RE: Data Responses, Informal Set 2
Cosumnes Power Plant (01-AFC-19)

**COSUMNES POWER PLANT
(01-AFC-19)**

**INFORMAL DATA RESPONSE,
SET 2**

COSUMNES POWER PLANT (01-AFC-19)
INFORMAL DATA RESPONSES, SET 2

Figure NO2-1
Noise Monitoring at Residence on Kirkwood
6/19/02 - 6/21/02

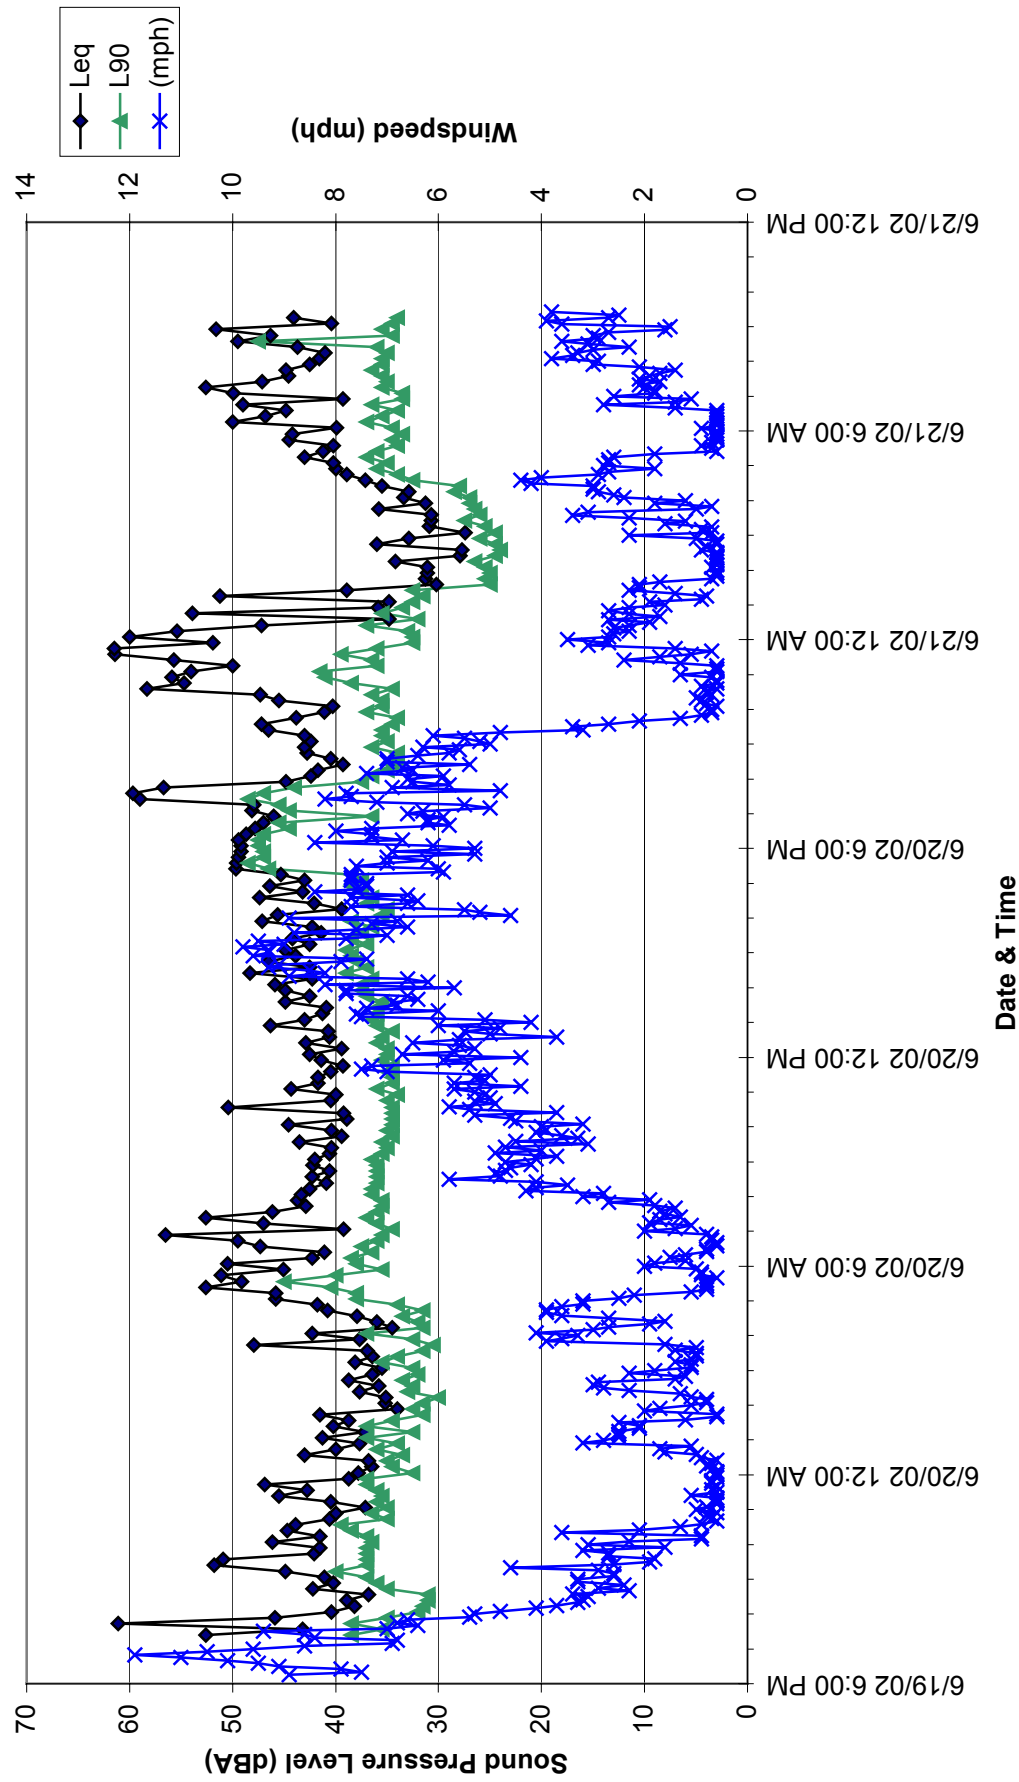
- NO-2. Please take ambient noise measurements at the Peasha's house and coordinate the data collection effort with Mr. & Mrs. Peasha and Jim Buntin.

Response: On Wednesday, June 19, 2002, CH2M HILL personnel met with Mrs. Peasha and conducted noise monitoring at the back of her home. The monitoring was conducted with the same equipment used to conduct the ambient monitoring for the AFC (Bruel & Kjaer 2236, Type 1). Data was recorded in terms of 10-minute Leq, L10 and L90, as was done for the AFC. On-site 5-minute average wind speed was also recorded. The monitoring period encompassed two nights and started at approximately 7 p.m. on June 19th and ended at approximately 9 a.m. on June 21st. Mr. Jim Buntin met with Mrs. Peasha the evening of June 20th and verified that the equipment was set in an appropriate location.

Temperature varied between the low 50 °F during the night and the mid-to high 90 °F during the daytime. Skies were clear during both the day and nighttime periods and humidity was low. Winds varied, but were generally below 8 mph. No nighttime noise from neighboring agricultural operations was observed by CH2M HILL, nor noted by Mrs. Peasha. A plot of the results is presented in Figure NO2-1. Table NO2-1 presents the

10-minute data. The 10 p.m. to 7 a.m. average L90 were approximately 35 dBA and 32 dBA for the first and second nights, respectively. The average L90 of the two nighttime periods was approximately 34 dBA.

FIGURE 8.11-6
MAPPED LINES-OF-SIGHT
"A" "B" AND "C"
 COSUMNES POWER PLANT
 APPLICATION FOR CERTIFICATION

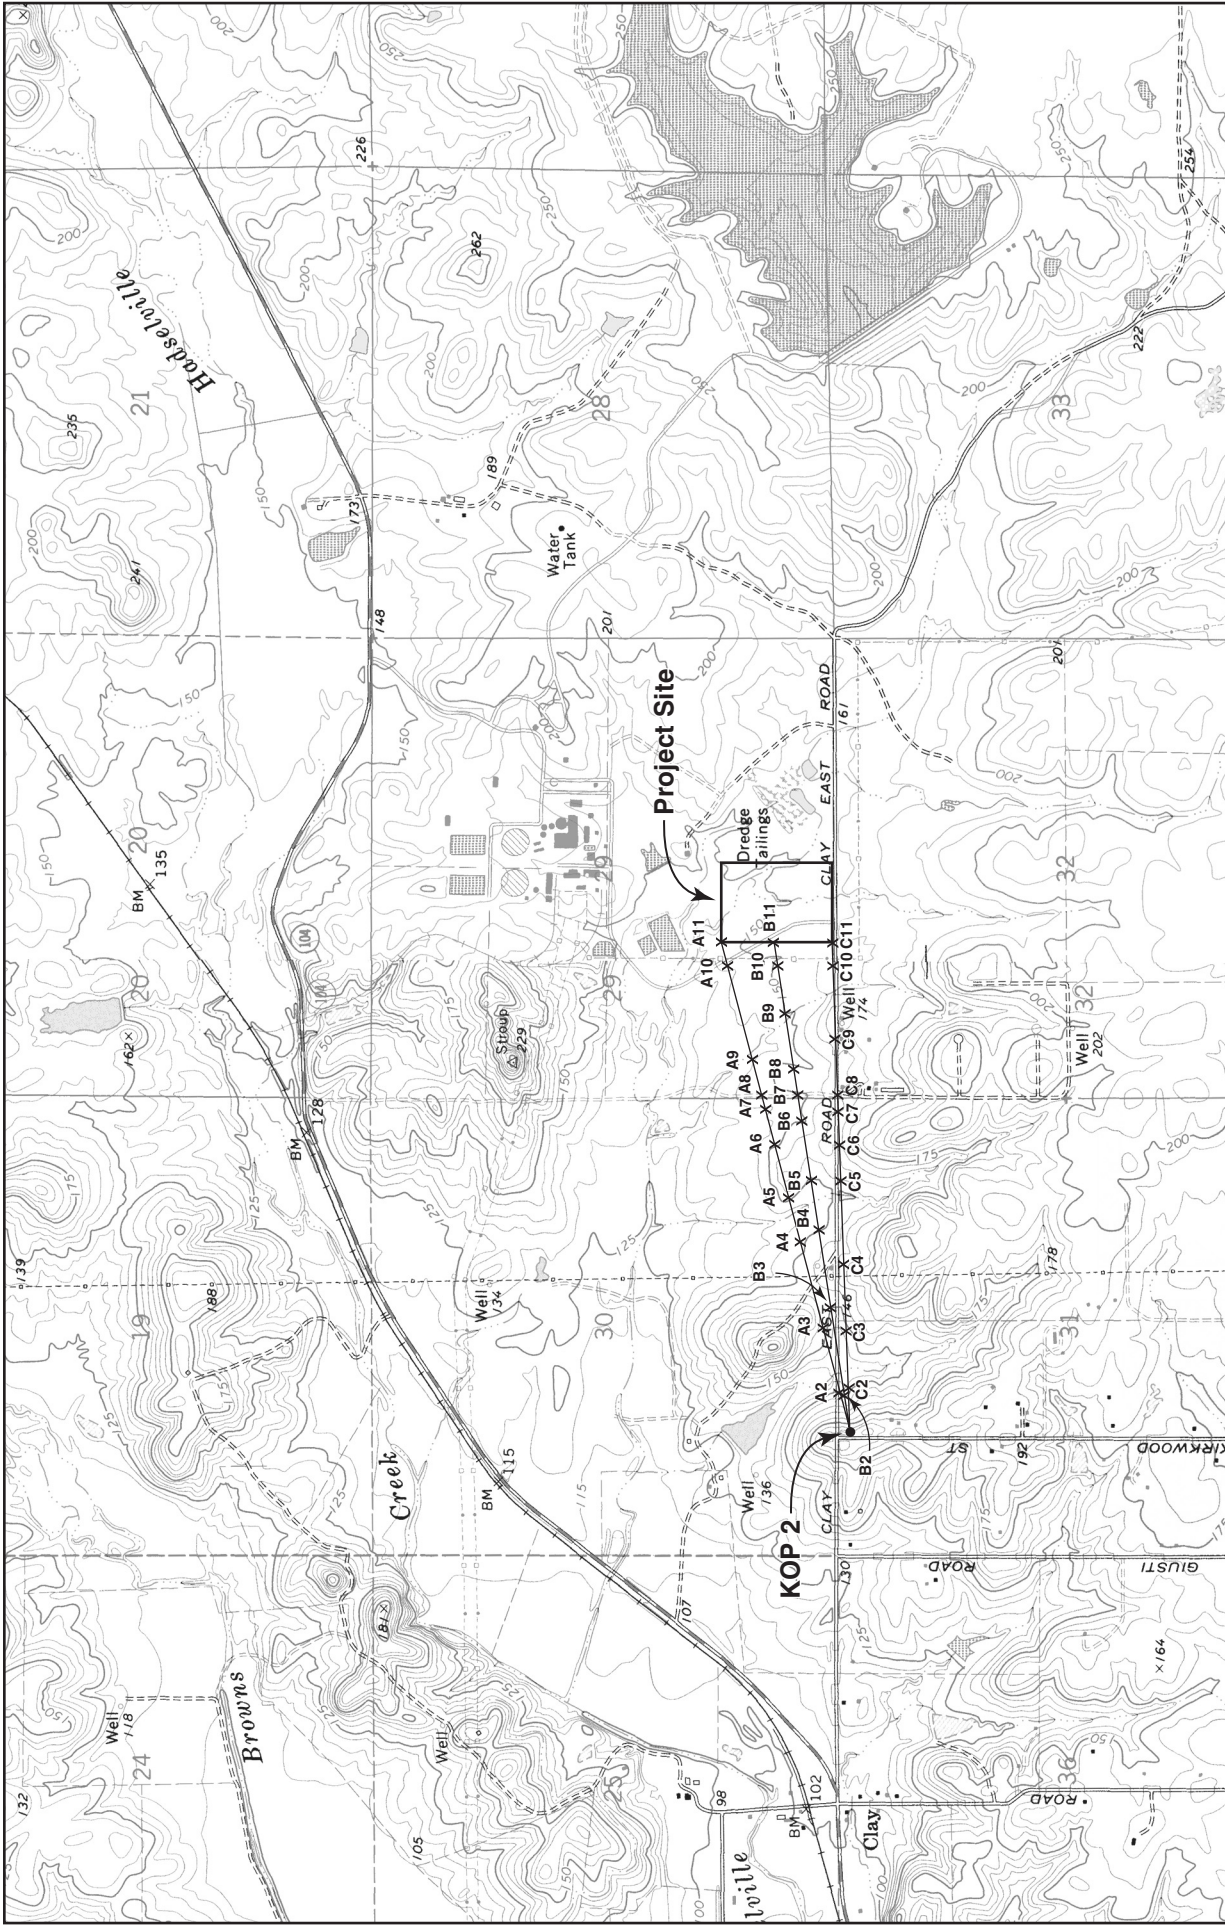
- VIS-1. The proposed power plant would be visible from KOP 2. Evaluate the feasibility of planting trees along the west side of the power plant to screen views of the plant's features from KOP 2 by preparing either line-of-sight drawings or visual simulations. Evaluate only evergreen species.

Response: To evaluate the feasibility of vegetative screening along the west side of the power plant, three lines-of-sight were drawn and evaluated, as follows.

Figure 8.11-6 was prepared that shows the relative locations of the KOP 2 residence and the proposed power plant, using a 7.5-minute quadrangle map as the base. Three straight lines were drawn from KOP 2 to the power plant. The first line connects KOP 2 to the northwest corner of the power plant site. This line is referred to as Line-of-Sight "A". A second line connects KOP 2 to the midpoint of the western boundary of the power plant site; this line is referred to as Line-of-Sight "B". A third line connects KOP 2 to the southwest corner of the power plant site. This line is referred to as Line-of-Sight "C".

"X"s were marked along the lines-of-sight on Figure 8.11-6 where they crossed contour lines shown on the quadrangle map. Eleven Xs were marked along each line-of-sight. The three lines-of-sight were then plotted as graphs. Figure 8.11-7 shows the line-of-sight for "A"; Figure 8.11-8 shows the line-of-sight for "B"; and Figure 8.11-9 shows the line-of-sight for "C".

Figure 1: East and West Tributary locations (shown on USGS Goose Creek Quad)

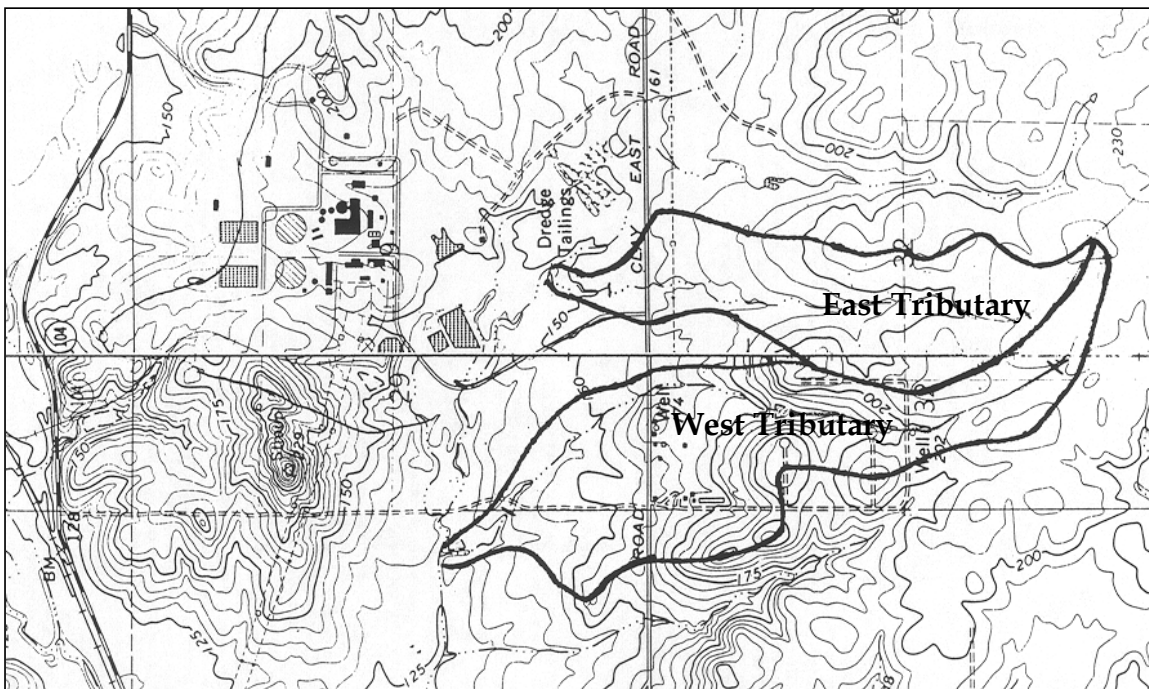
W&SR-4. Please provide HEC 1 hydraulic calculations to show how flow will be accommodated.

Request: Please provide 100-year discharges for the Clay Creek tributaries that will be diverted by the CPP using the rational method.

Response: We estimated the 100-year peak discharges for the Clay Creek tributaries that will be diverted by the CPP using the rational method (as described in Dunne and Leopold 1978).

We delineated areas for the “east “ and “west” tributaries to Clay Creek (Figure 1) on the United State Geological Survey (USGS) Goose Creek and Clay Quadrangles. The drainage areas were measured with a planimeter as 125 and 194 acres, respectively. *Note – A field investigation conducted after this document was prepared confirmed that only the East Tributary will be diverted by the CPP.*
